TONNEAU BULLETIN

Rugged Folding Cover Latch Update

New Latch

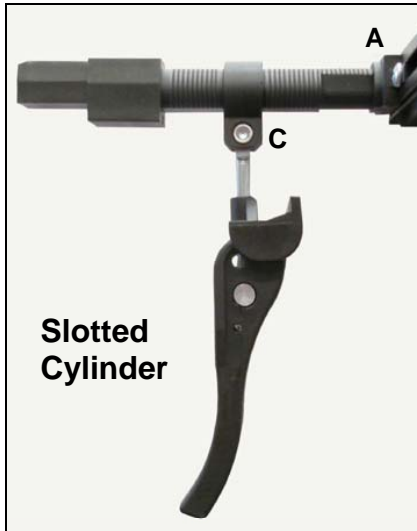
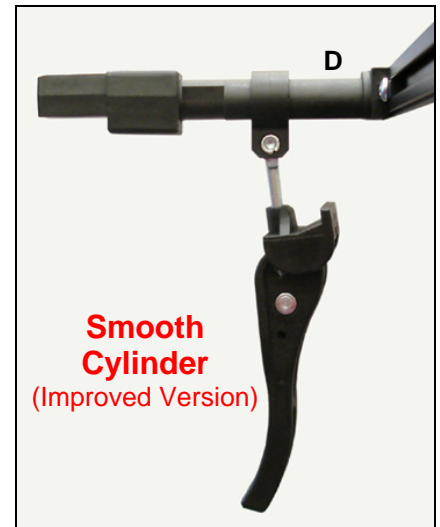
We have removed the slots on the latch cylinder so the collar will slide smoothly.

- A. Set screw Exposed.
- B. Handle storage location on side rail.
- C. Threaded rod mounts on pivot point below the collar.
- D. Removed slots on cylinder.

- Adjustable bow and latch for relocation or replacement.
- Prevents puncture of vinyl when folding.
- Relieves pressure on the threaded rod during the latching motion.
- Collar slides smoothly from side to side.
